Access Compliance Report Public Rights-of-Way (Curb Ramps)

Main Street: ASCENSO_AVE		Cross Street: SENDERO_WAY		Location:	S
ADA ID: RPRK211117152703	Ramp Type:Type 1 - Perpendicular	Initial Pass/Fail: Fail	Overall Compliance: No	Severity Score:	15
Codes/Mitigation Info/Possible Solution			Field Measurements/Component Compliance

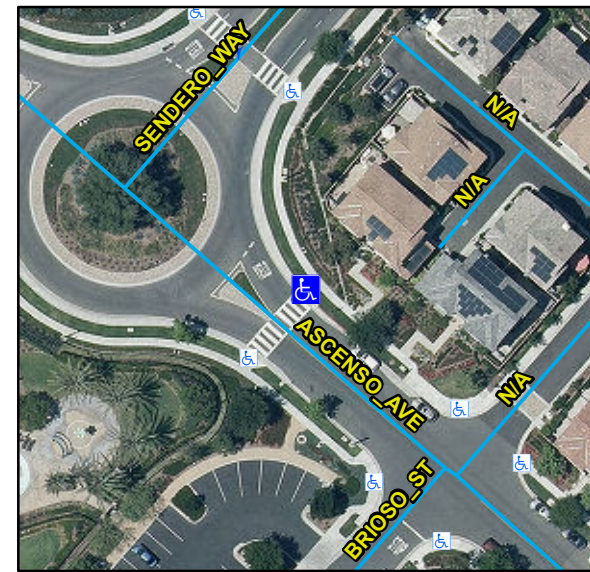
R304.2.2, R204.3, STD 1115

Remove & Replace Entire Ramp.
